City of Ketchum

Recommendation to approve the Lofts @ 660 Condominium Subdivision Final Plat

A CONDOMINIUM PLAT SHOWING
THE LOFTS @ 660 1ST AVENUE
 A CONDOMINIUM PLAT OF LOT 6, BLOCK 34, KETCHUM TOWNSITE
 LOCATED WITHIN SECTION 13, T.4 N., R.17 E., B.M., CITY OF KETCHUM, BLAINE COUNTY, IDAHO
 FEBRUARY 2021

IN RE:)	
)	
Lofts at 660 1 st Avenue Condominium Subdivision)	KETCHUM CITY COUNCIL
Preliminary Plat)	FINDINGS OF FACT, CONCLUSIONS OF LAW, AND
Date: March 1, 2021)	DECISION
)	
File Number: P20-095)

THE LOFTS @ 660 1ST AVENUE
 GALENA ENGINEERING, INC.
 HAILEY, IDAHO
 SHEET 1 OF 3
 Job No. 7724

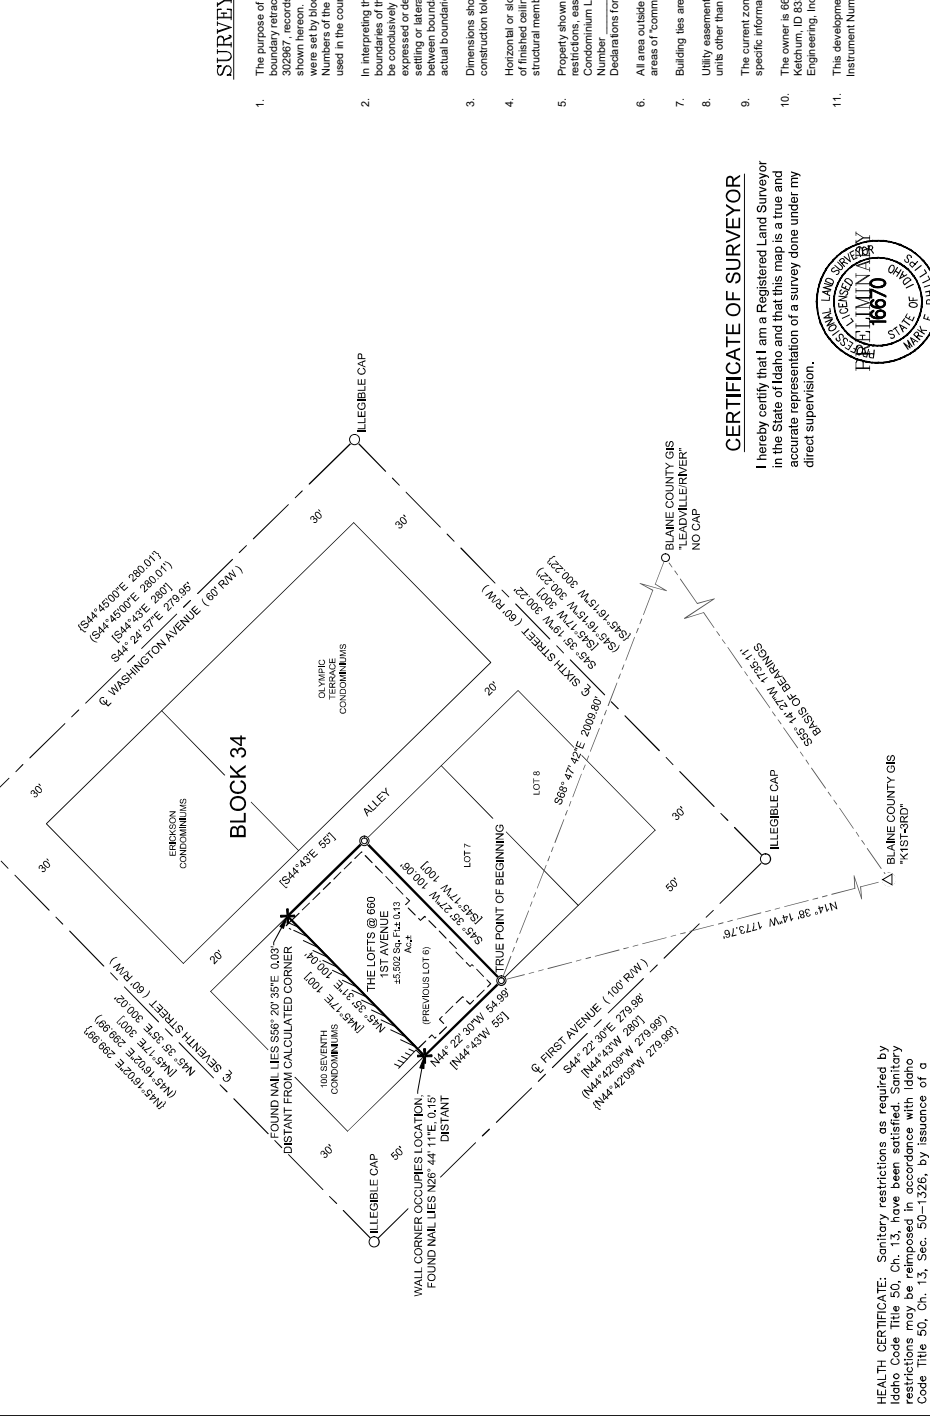
1. The recorded plat shall show a minimum of two Blaine County Survey Control Monuments with ties to the property and an inverse between the two monuments. The Survey Control Monuments shall be clearly identified on the face of the map.

THE LOFTS @ 660 1ST AVENUE
 GALENA ENGINEERING, INC.
 HAILEY, IDAHO
 SHEET 2 OF 3
 Job No. 7724

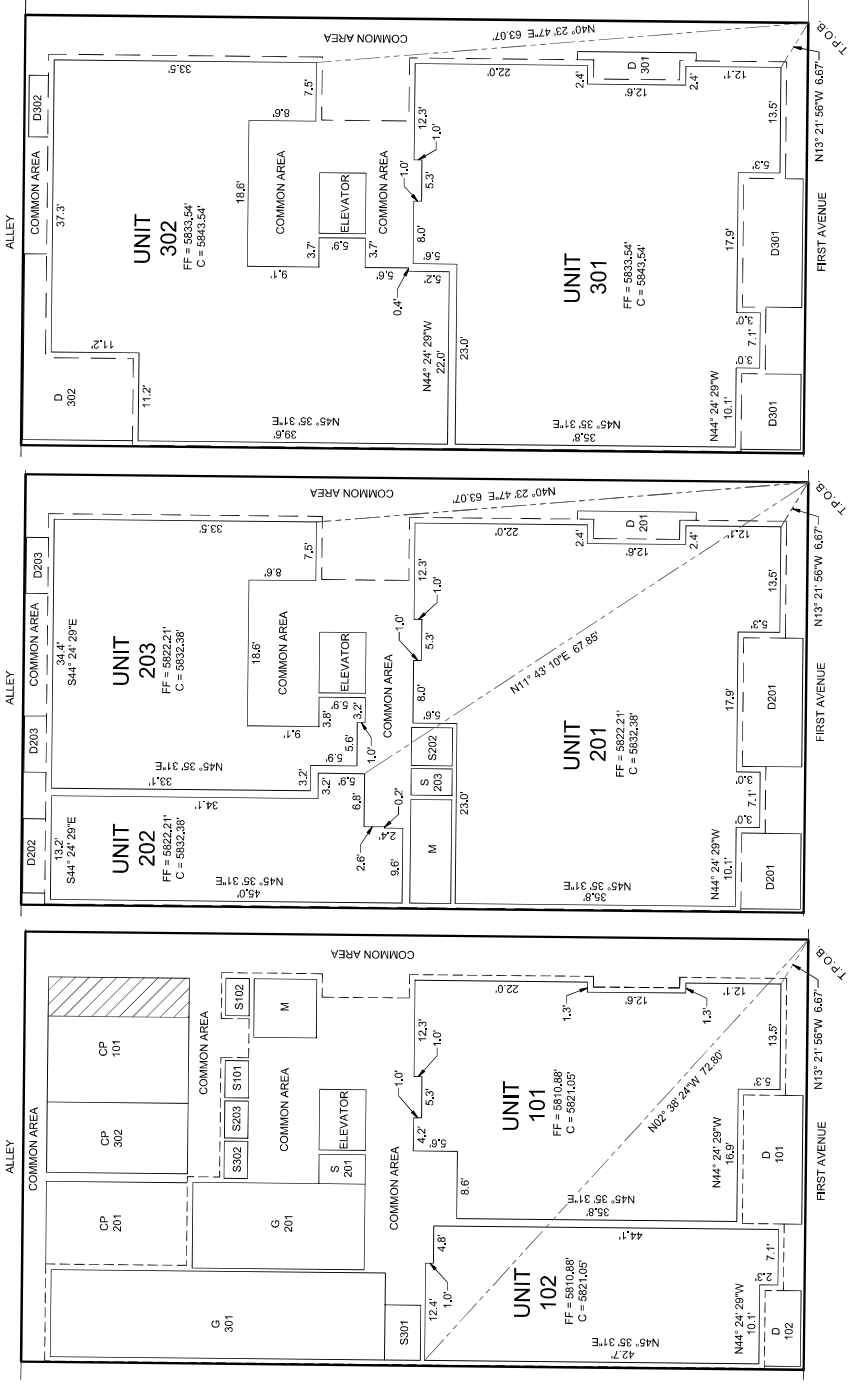
<input checked="" type="checkbox"/>	<input type="checkbox"/>	<input type="checkbox"/>	16.04.070.F	<p>Maintenance Building: A maintenance building or room shall be provided of adequate size and location for the type and size of the condominium project for storage of maintenance equipment and supplies for common areas.</p>
			<i>Staff Comments</i>	<i>Mechanical room is indicated on the plat.</i>
<input checked="" type="checkbox"/>	<input type="checkbox"/>	<input type="checkbox"/>	16.04.070.G	<p>Open Space: The subdivider shall dedicate to the common use of the homeowners adequate open space of such shape and area usable and convenient to the residents of the condominium subdivision. Location of building sites and common area shall maximize privacy and solar access.</p>
			<i>Staff Comments</i>	<i>All units have exterior space and these spaces are labeled "D" with the condominium unit number.</i>
